CLEAR DRIVE COURT

Approved Septic System Plan
Howard County Health Department

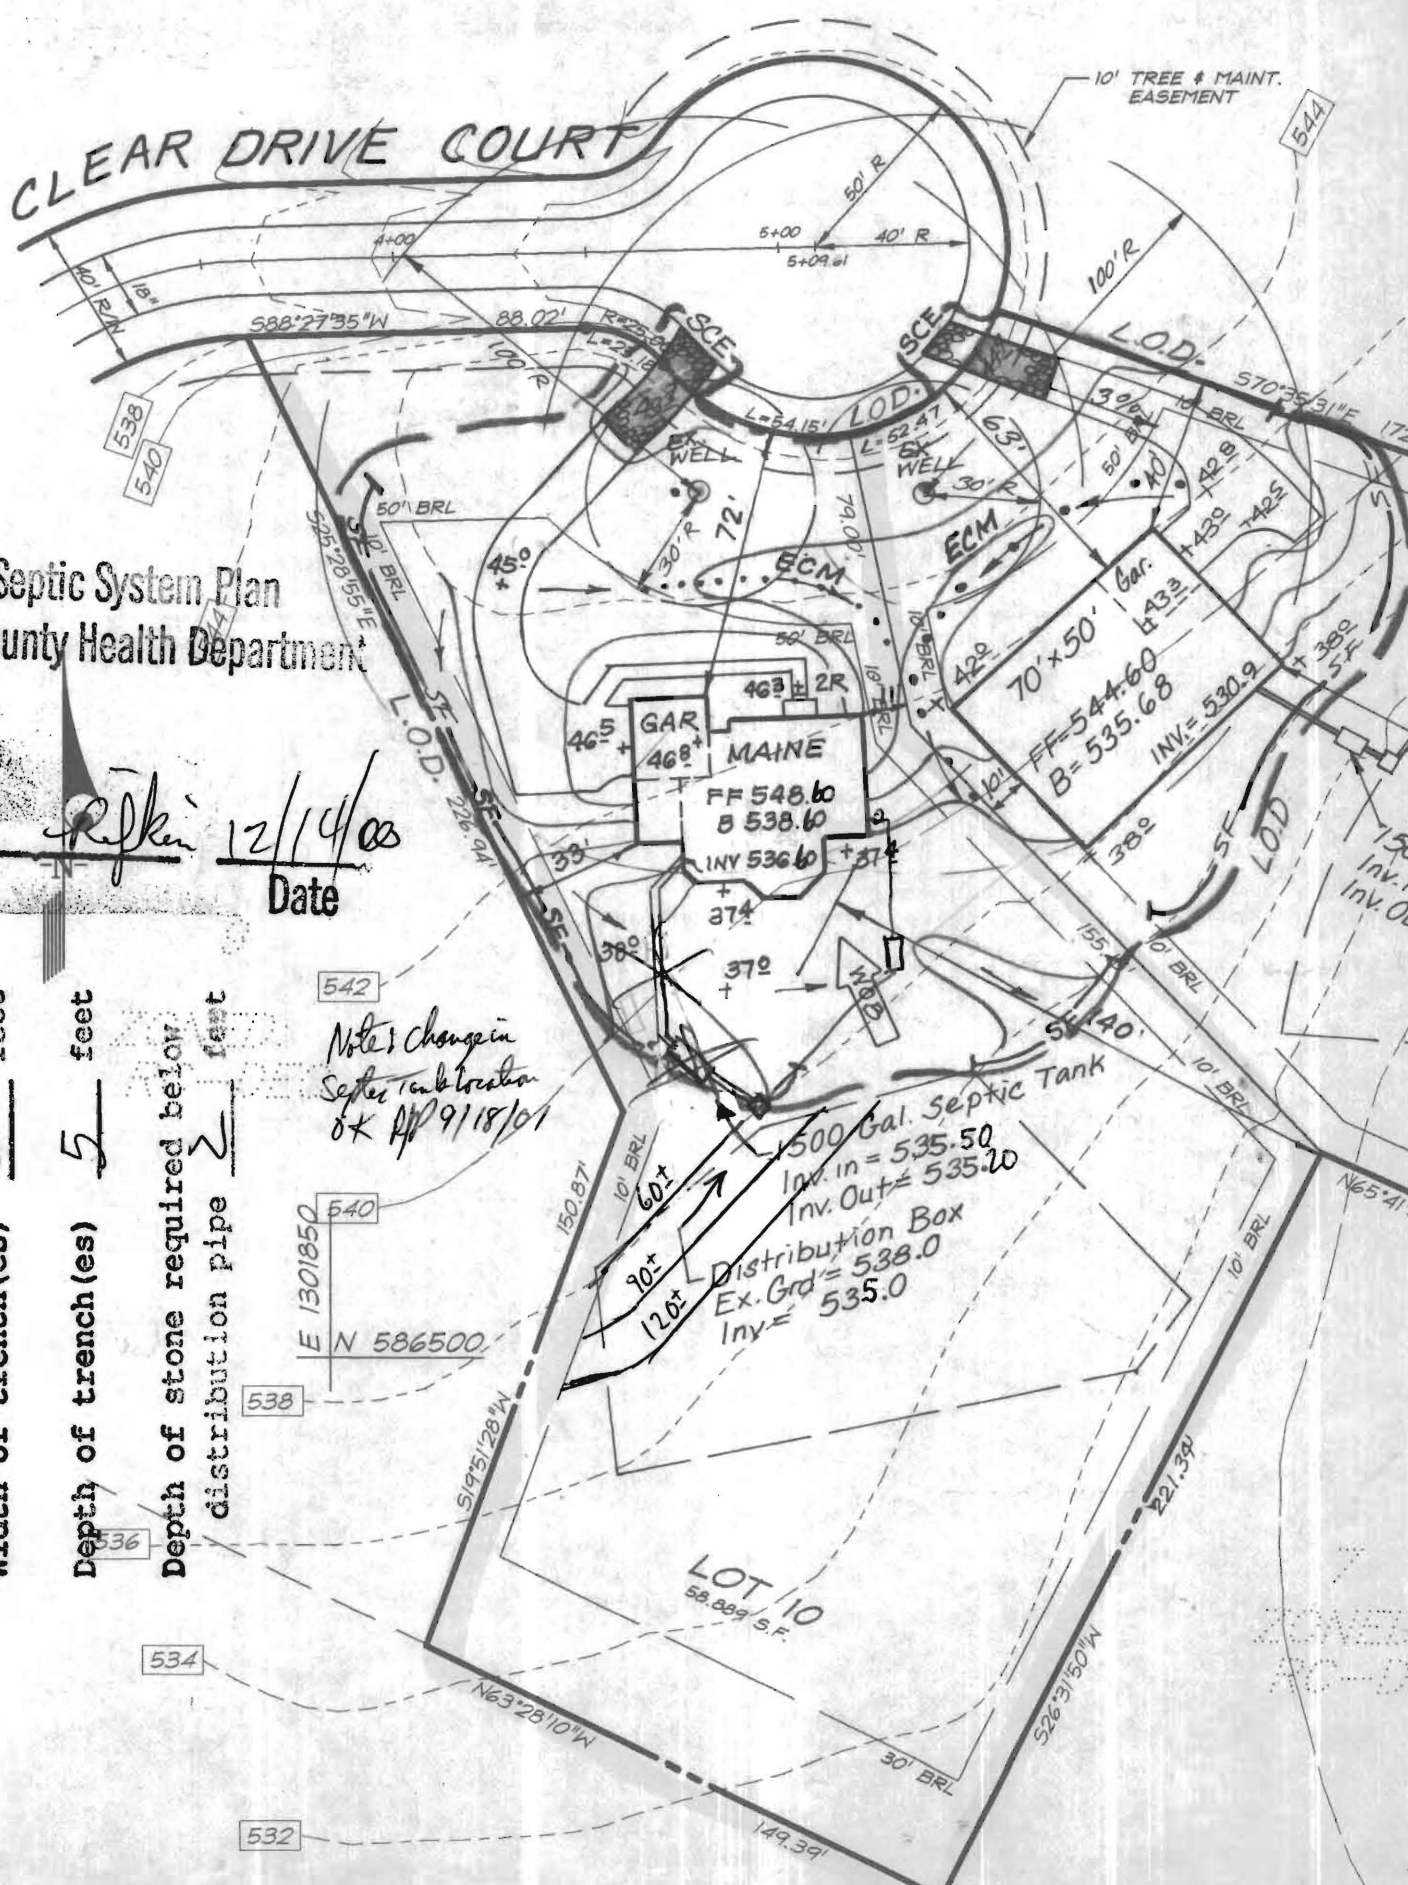
Note: Change in Septic tank location OK AP 9/18/07
